# Value Planning Report

## Plan Formulation Project South Utah & Juab County, UT

Workshop Dates: June 24-28, 2024  
Report Date: October 29, 2024

Final  
Value Engineering Study Report  
for

Alternative No.: DW-02

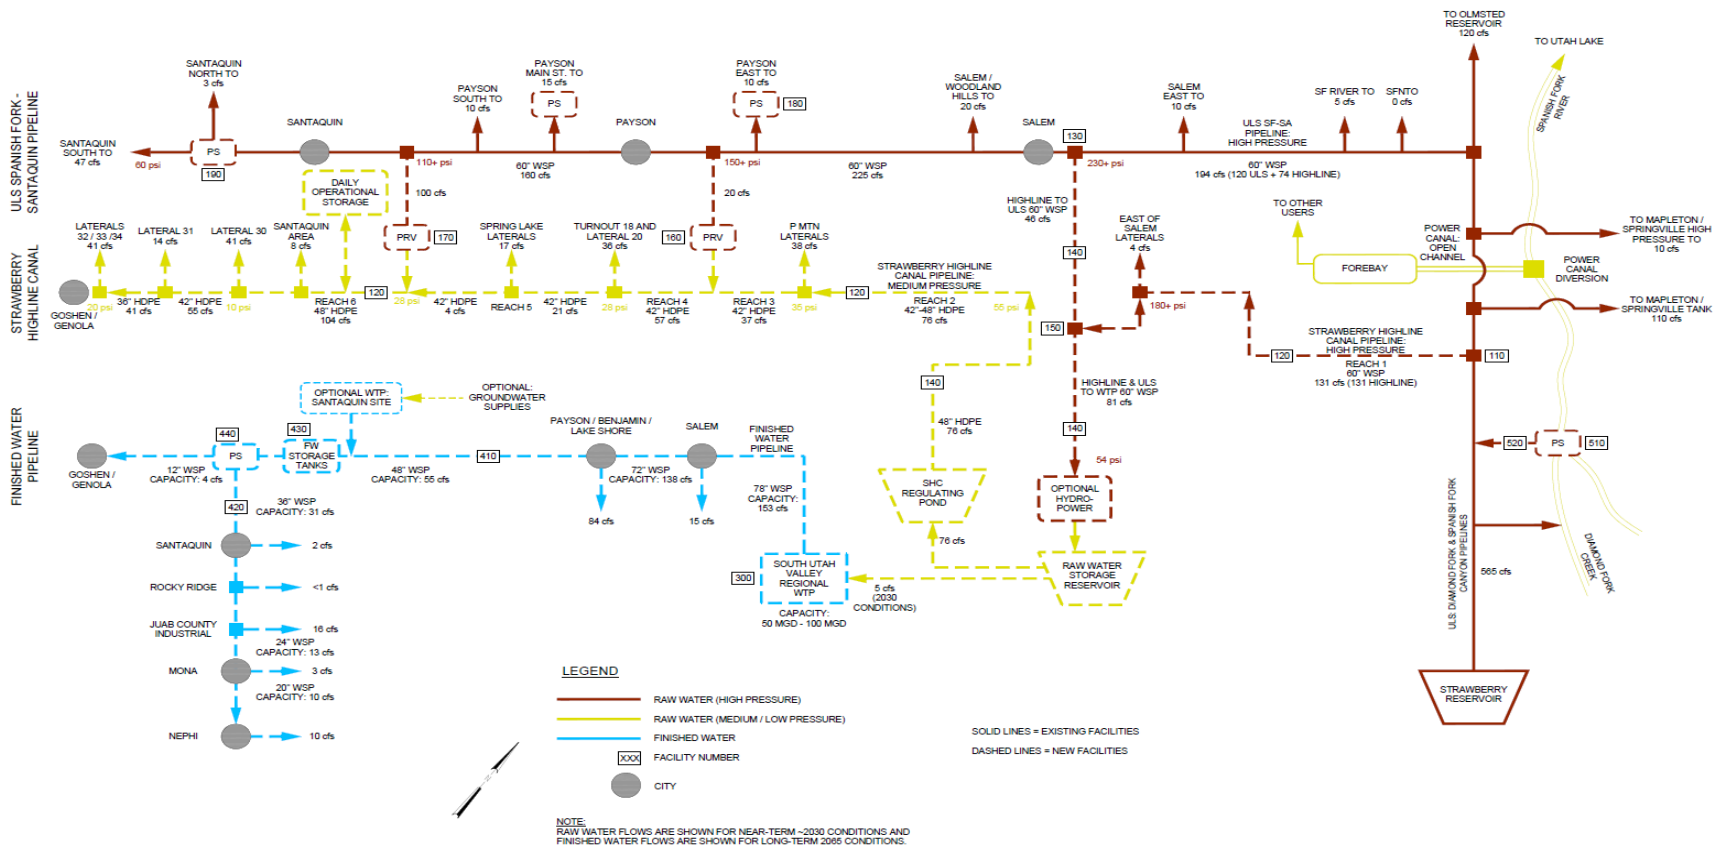
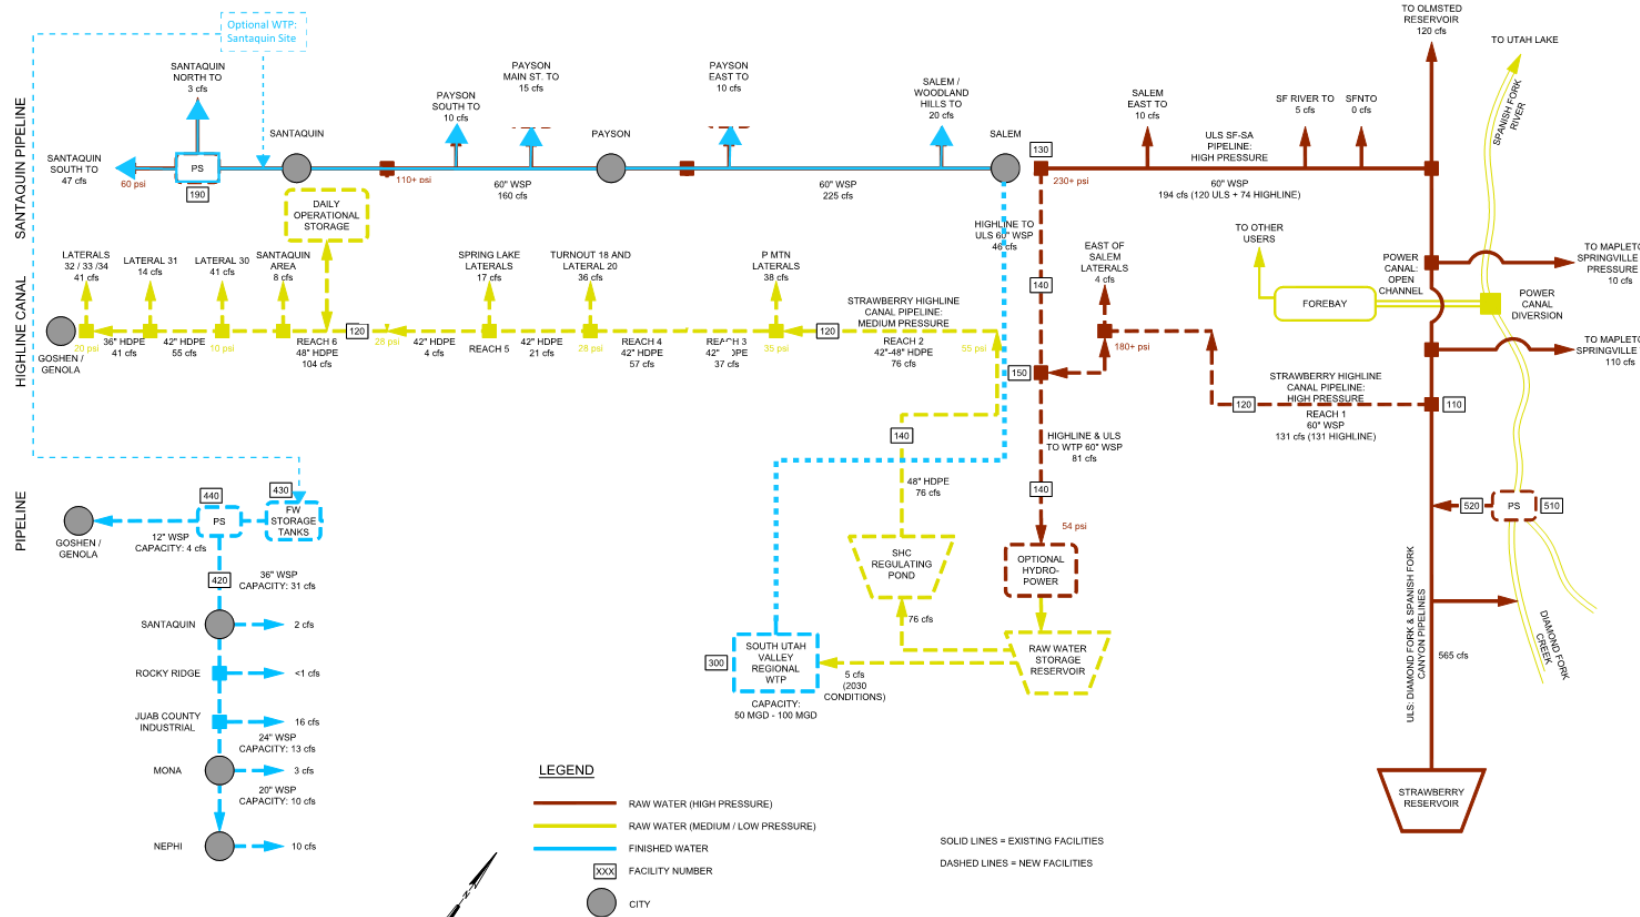
DW-02  
Use the ULS to convey finished water from South Utah Valley Regional Water Treatment Plant to Santaquin and enlarge the Strawberry Highline Canal enclosure to accommodate the ULS water ..... 4-6

Alternative No.: DW-06

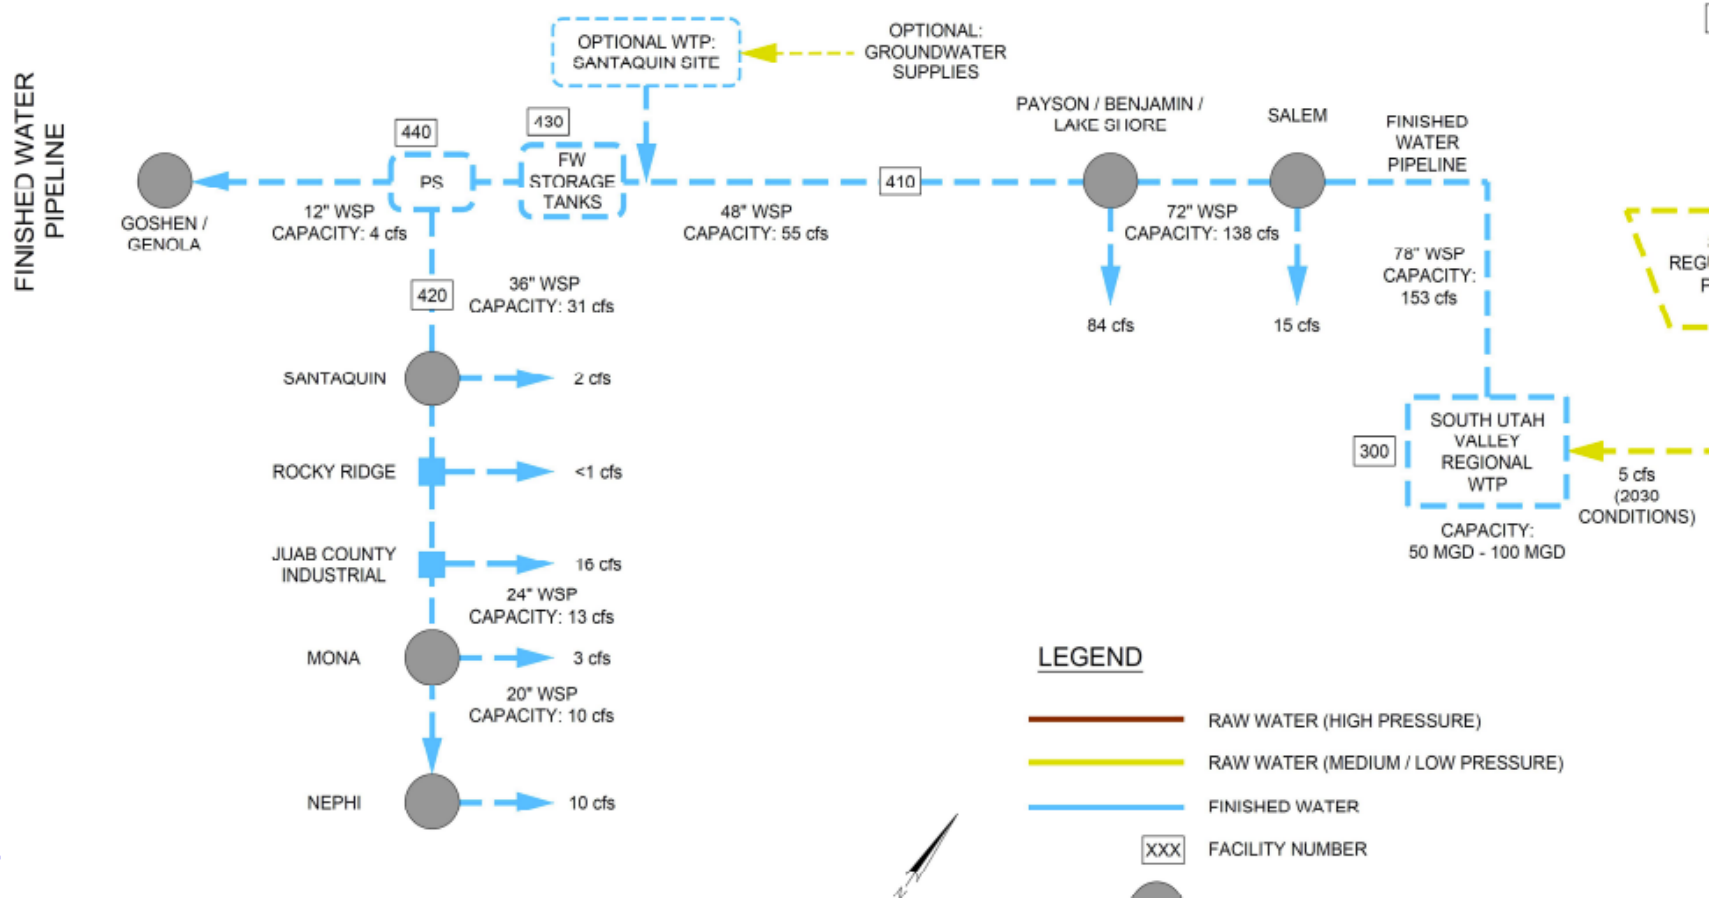
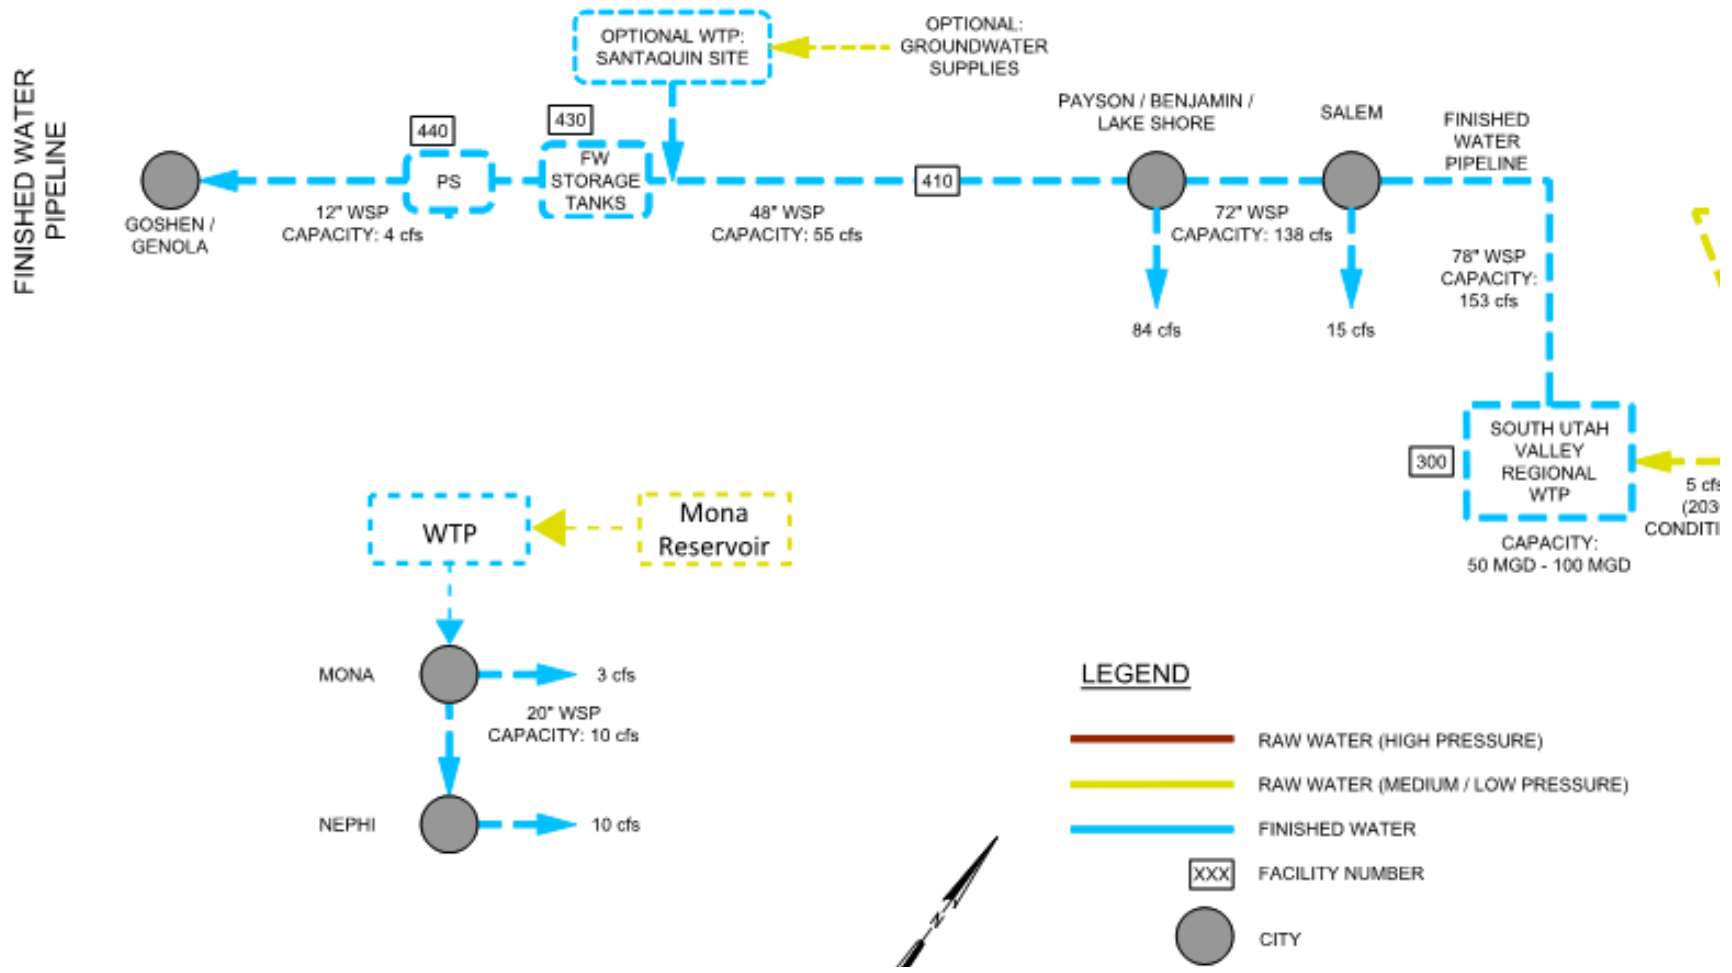
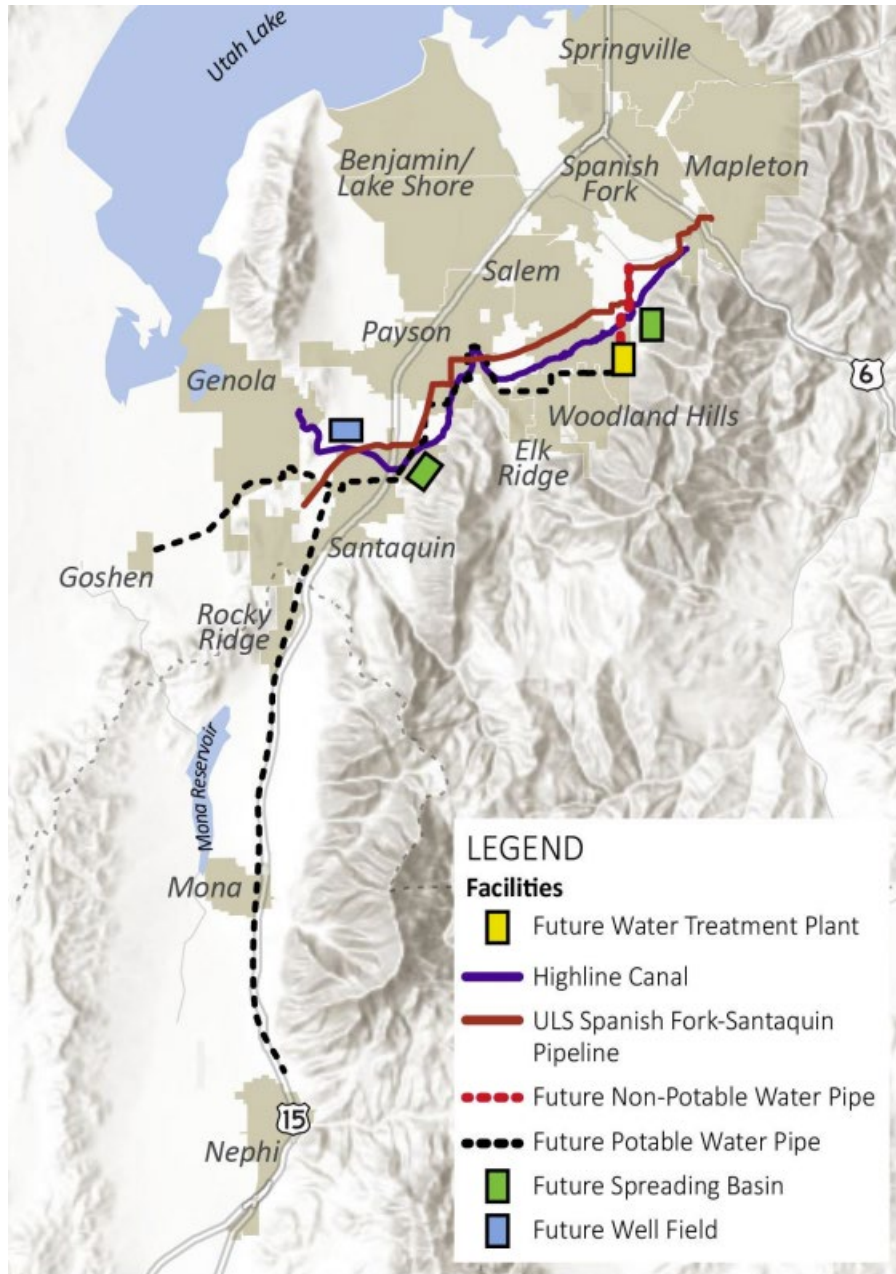
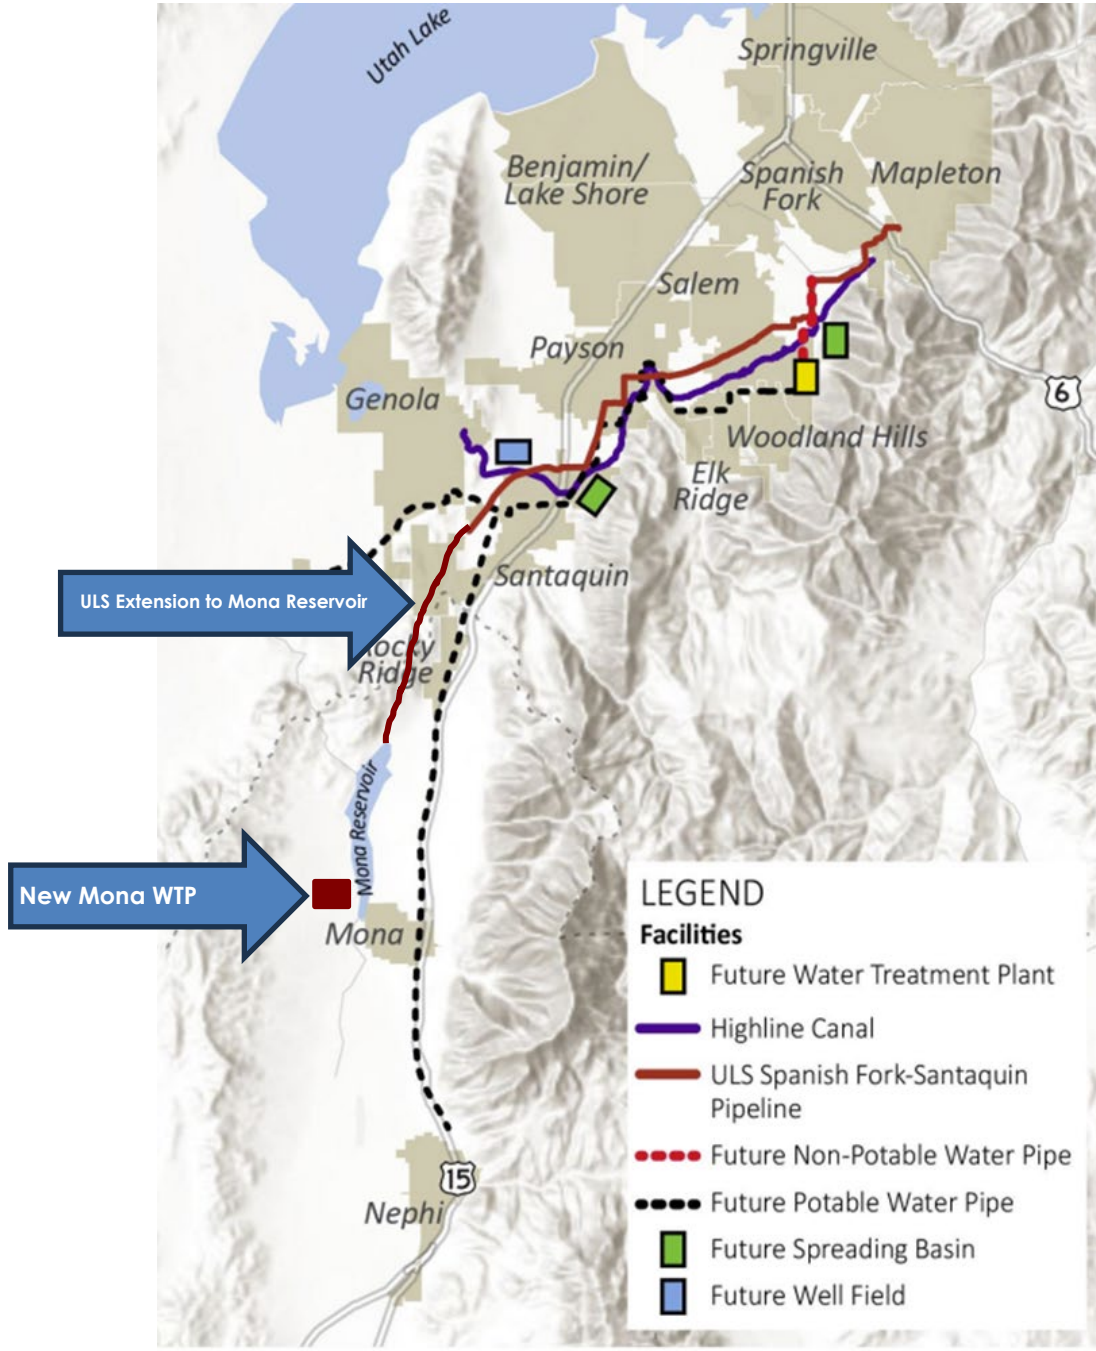
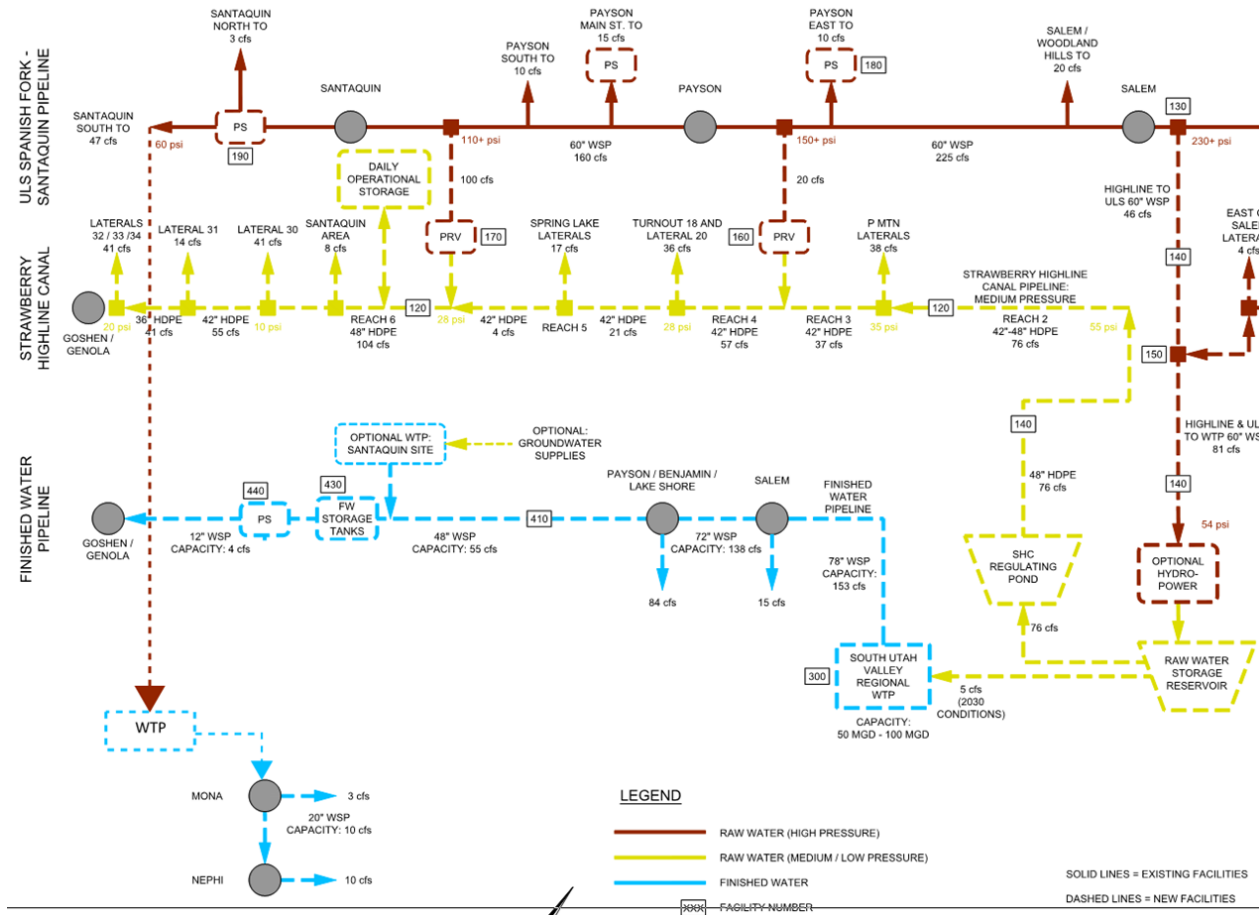
DW-06  
Develop a third water treatment plant at Mona to eliminate some finished water pipeline ..... 4-15

Initiate discussions with the water rights holders in the Mona Reservoir to propose the use of 13 CFS of water rights in exchange for 13 CFS of raw water to be delivered from the ULS pipeline to the Goshen area near Santaquin. In the future, this raw water will be converted to finished water for Goshen, provided by the future Santaquin WTP. A water rights change of diversion would need to be implemented for this alternative if negotiations with water rights owners are successful.

Additionally, locate and acquire a site for the new Mona WTP and secure the right-of-way for a pipeline from Mona Reservoir to the new Mona WTP. Confirm the size of the new Mona WTP, considering potential industrial demands in Juab County. Initiate the design and construction of a finished water pipeline between Santaquin and Goshen. Start discussions with Rocky Mountain Power regarding the potential lease of well water from their Currant Creek Power Plant. Lastly, contact the Central Utah Office regarding the construction of the ULS Pipeline from Santaquin to Mona Reservoir.
